RENESAS TECHNICAL UPDATE

Product Category	MPU/MCU		Document No.	TN-RA*-A0004A/E	Rev.	1.00
Title	Errata for User's Manual: Hardware for SCE5		Information Category	Technical Notification		
Applicable Product	RA4M1 Group	Lot No.	Reference Document	RA4M1 Group User's Manual Hardware Rev.1.00		
		All

Figure 46.1 SCE5 block diagram

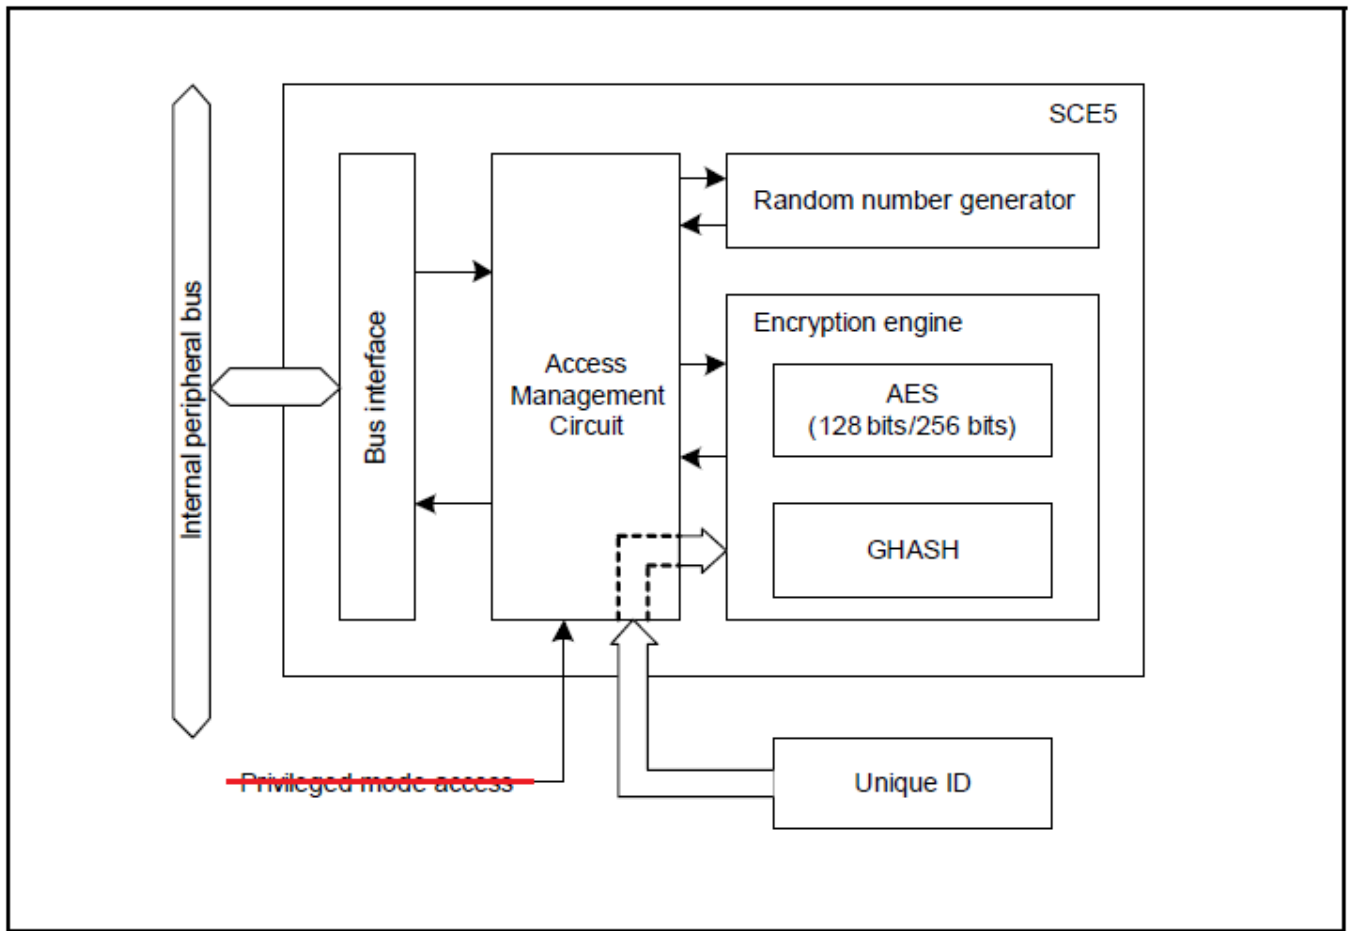
SCE5 is used in user mode and privileged mode. Therefore, the following descriptions should be deleted.

- In Table 46.1 SCE5 specifications, specification, Privileged mode: The privileged mode access signal is connected to the access management circuit and is used to limit control of the SCE5 module to privileged mode only.
- In Figure 46.1 SCE5 block diagram, Privileged mode access.
